INTERNATIONAL ORGANIZATION OF MOTOR VEHICLE MANUFACTURERS

Informal document No. GRB-52-04
(52nd GRB, 06-08 September, agenda item 3.a)

Noise Emission of Moving Vehicles in Urban Areas

**Proposal for Change of the Wording in §2.2.2
for the Tyres to be Used for the Test**

Comparison: Traction Tyres vs Normal Tyres

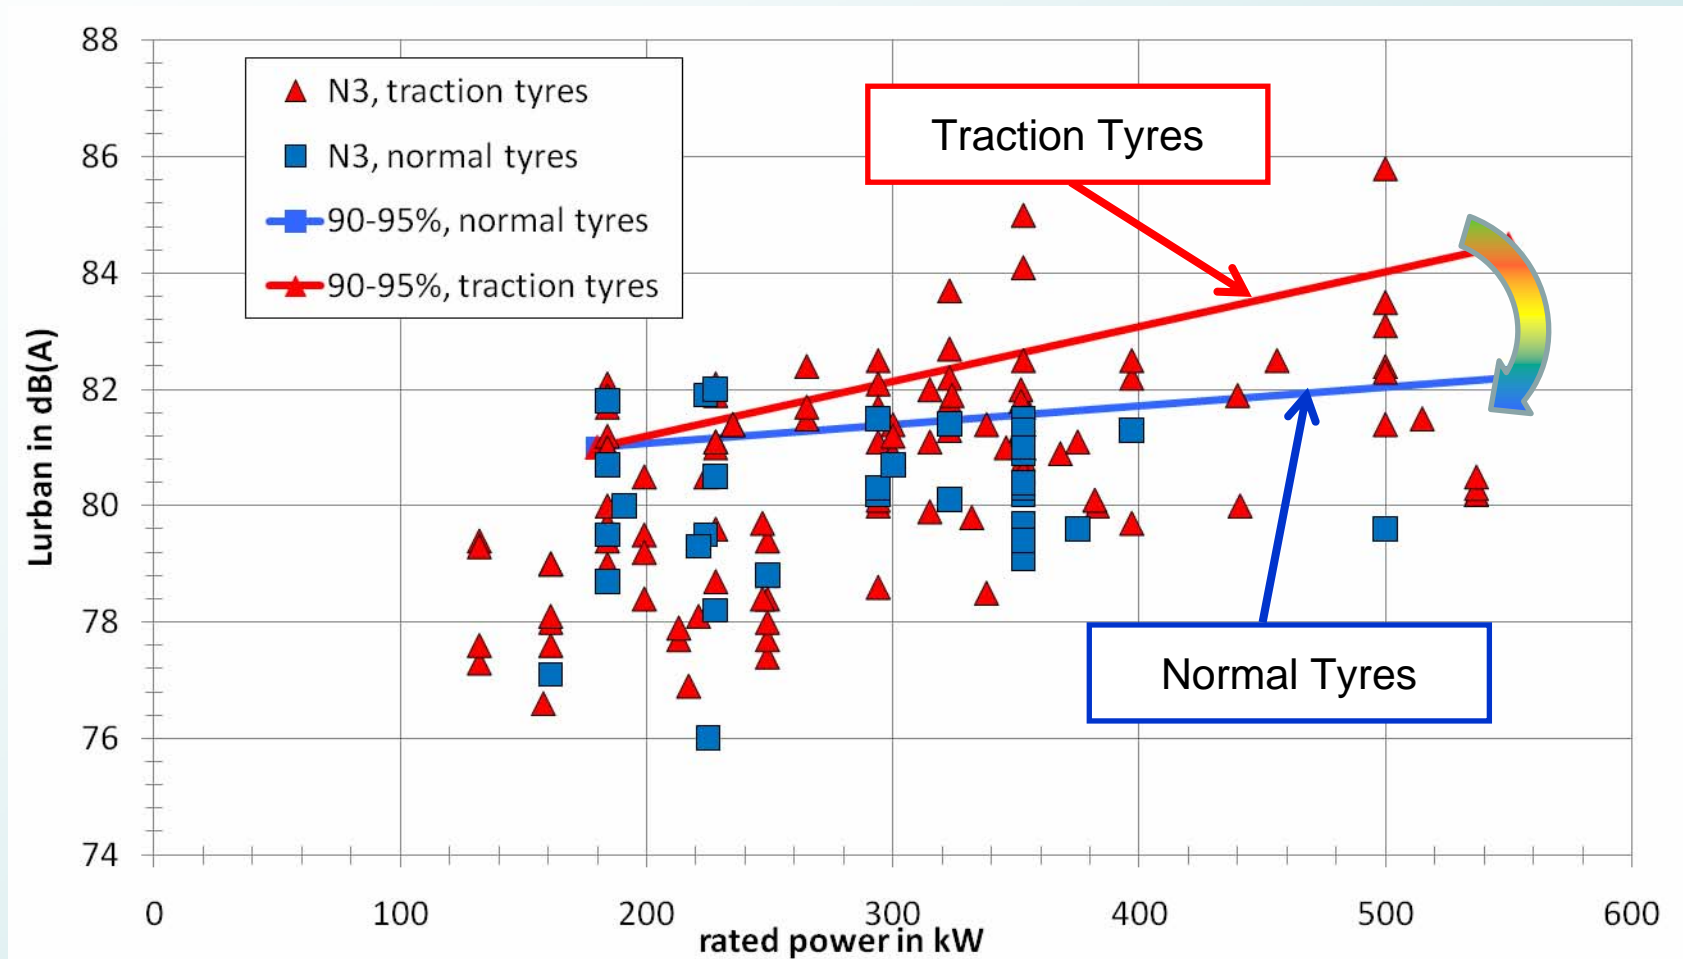
➤ **The new noise test procedure for HCV according to ISO 362-1:2007 is rather sensitive to the choice of the tyres**

2/ The tyre contribution for overall sound emission being important, this Regulation has taken into account the tyre/road sound emission regulations. **Traction tyres, snow tyres and special use** tyres according to UNECE Regulation No. 117 **as amended by the 02 series of amendments (2010)** shall be excluded during type-approval- and COP-measurements on request of the manufacturer.
